**Milford Welcome Center
Home of the Milford Museum
400 NE Front Street Milford, Delaware
Project No. 1884A003.A01
Bid Pac A – Contracts 1 thru 9
February 28, 2025**

Addendum No. 1

1" = 1'-0"

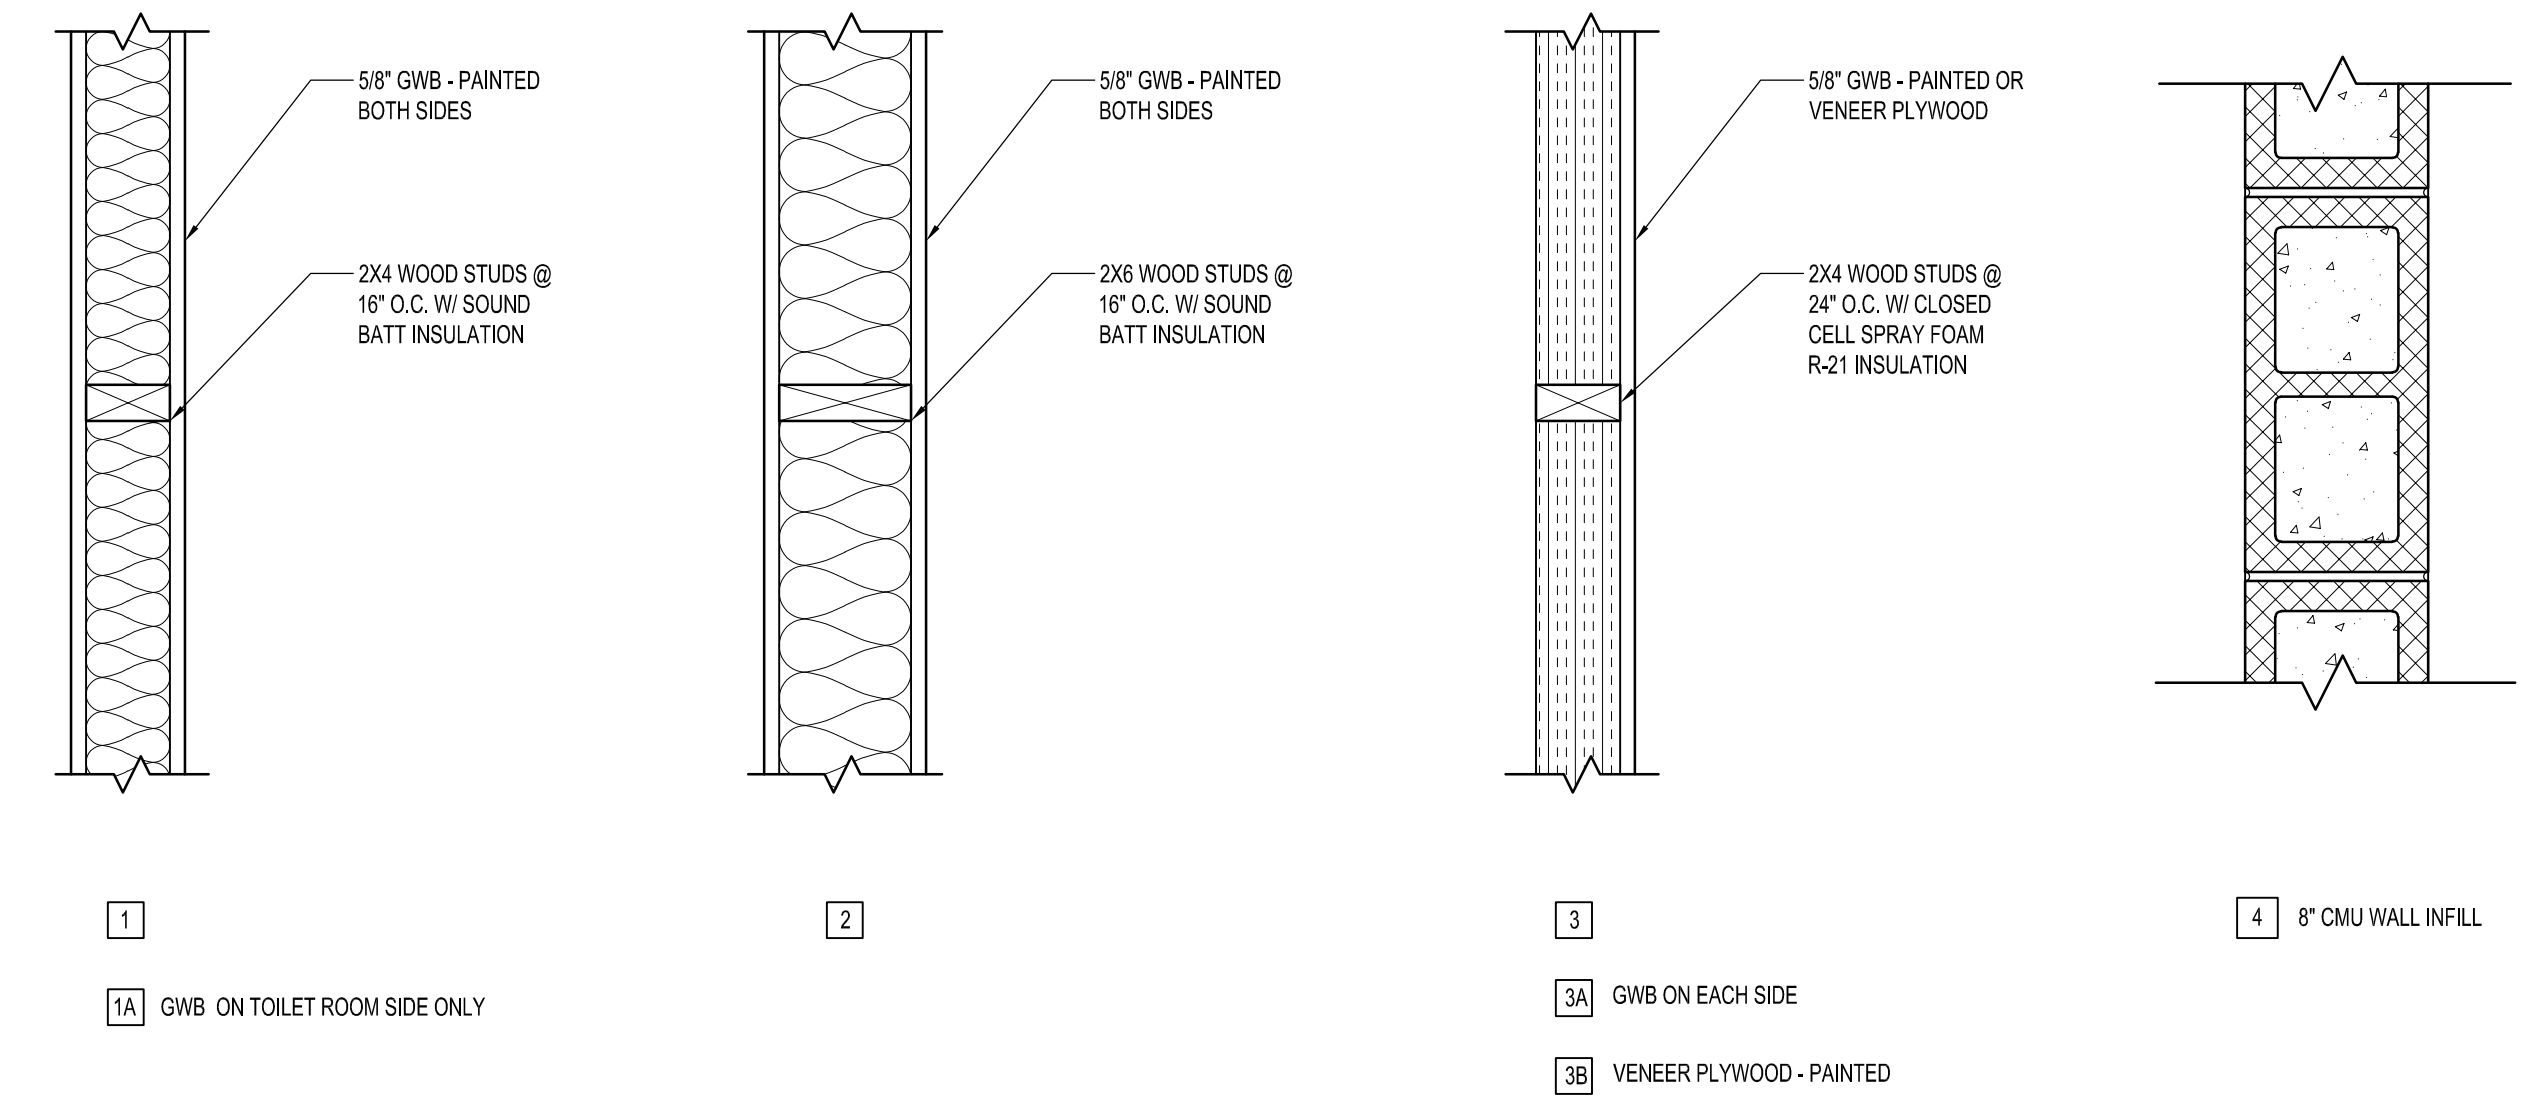
DATE	COMMENTS
02/26/2025	DETAIL ADDED
